1199 Panigale Safety Upgrades
Models: MY 2012 and MY 2013 Panigale (All Versions)
Recall Bulletin RCL-12-006

Date: Tuesday, August 7th, 2012
To: Dealer Principal, Service Manager, North American Dealer Network
From: Austin Gray, Technical Director; Jonathan LaForte, Technical Manager

Description of the technical problem:

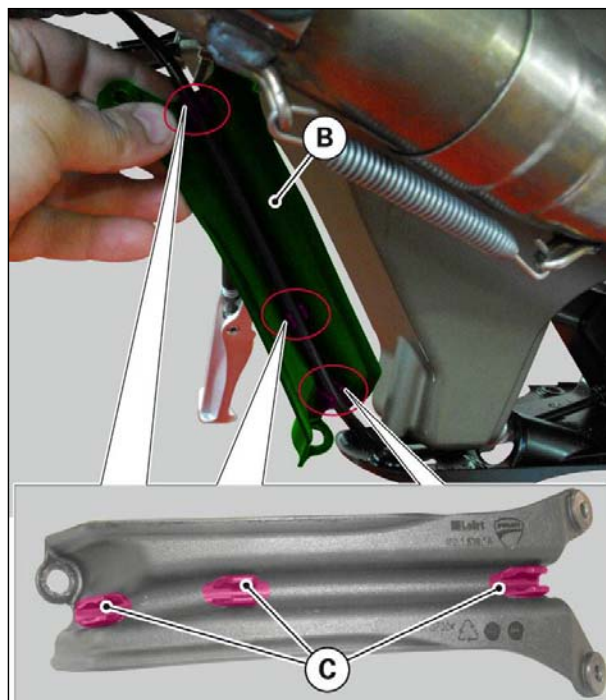
- 9) Install the new *exhaust butterfly valve Bowden cable support (B)* part no. 46015393A and engage the cable inside the *three clips (C)*.

- 10) Fit the new exhaust butterfly valve Bowden cable support (B) part no.46015393A and tighten the **bottom screw (7)** to **$5\text{ Nm} \pm 10\%$** after applying **LOCTITE 222**, then tighten the **two top nuts (8)** to **$6\text{ Nm} \pm 10\%$** .

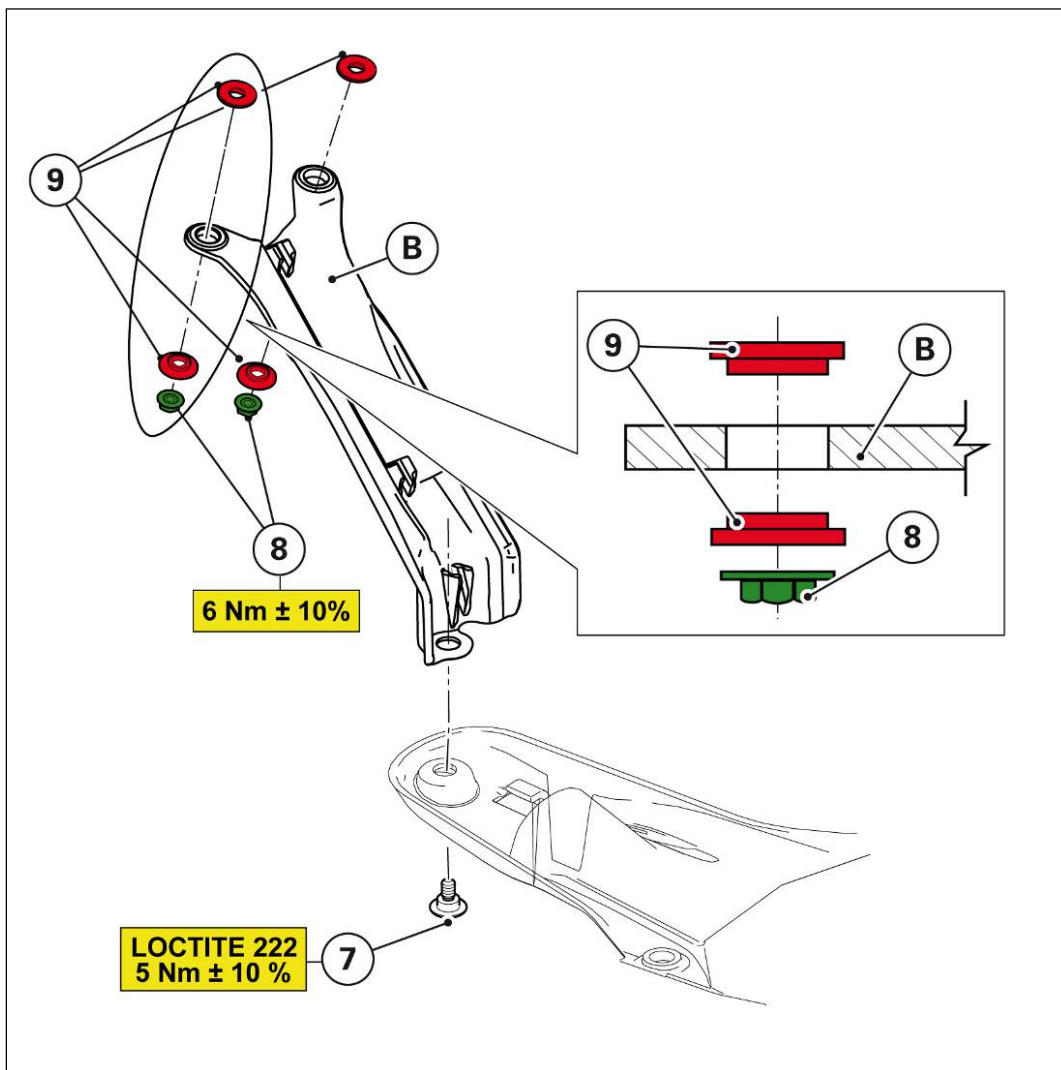
Fit the four **spacers (9)** correctly, as shown below.

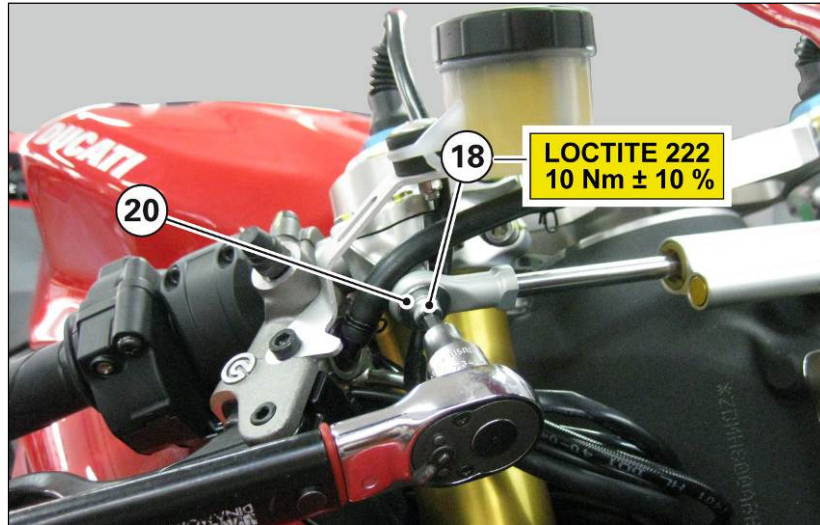
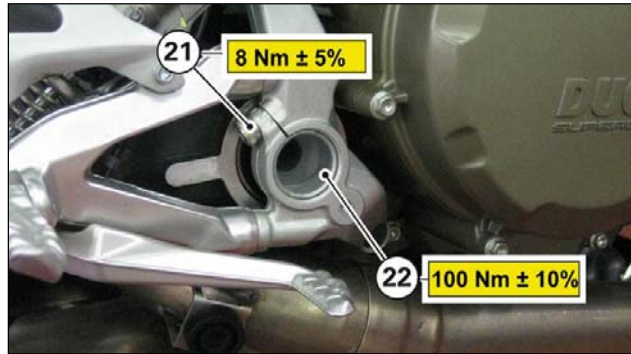
5) Tighten the **screw (18)** with **LOCTITE 222** to **10 Nm \pm 10%**.

Washer (20) must be installed only on S versions, i.e., where an Ohlins steering damper is fitted. The washer must NOT be installed on BASE versions equipped with SACHS steering damper.

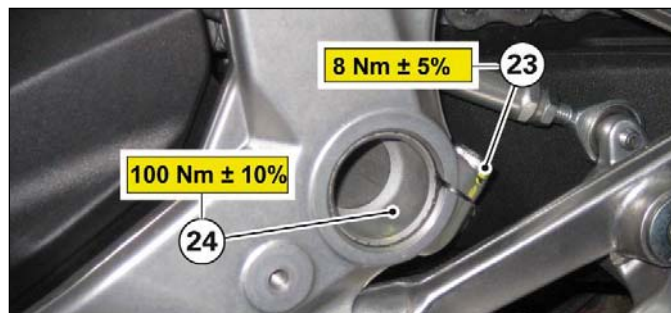
- 1) Loosen the **screw (21)** from clamp on RIGHT-hand swinging arm shaft.
- 2) Loosen the **RIGHT-hand swinging arm shaft (22)** by 180° without removing it.
- 3) Tighten **RIGHT-hand swinging arm shaft (22)** to **100 Nm ± 10%**.
- 4) Tighten clamp **screw (21)** to **8 Nm ± 5%**.

- 5) Slacken the **screw (23)** from clamp on LEFT-hand swinging arm shaft.
- 6) Loosen the **LEFT-hand swinging arm shaft (24)** by 180° without removing it.
- 7) Tighten **LEFT-hand swinging arm shaft (24)** to **100 Nm ± 10%**.
- 8) Tighten clamp **screw (23)** to **8 Nm ± 5%**.

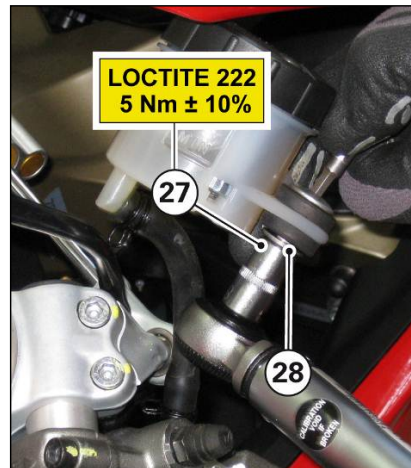
- 2) Start the new **cap nut (27)** and add the **washer (28)**. Tighten the **cap nut (27)** with **LOCTITE 222** to **5 Nm \pm 10%**.
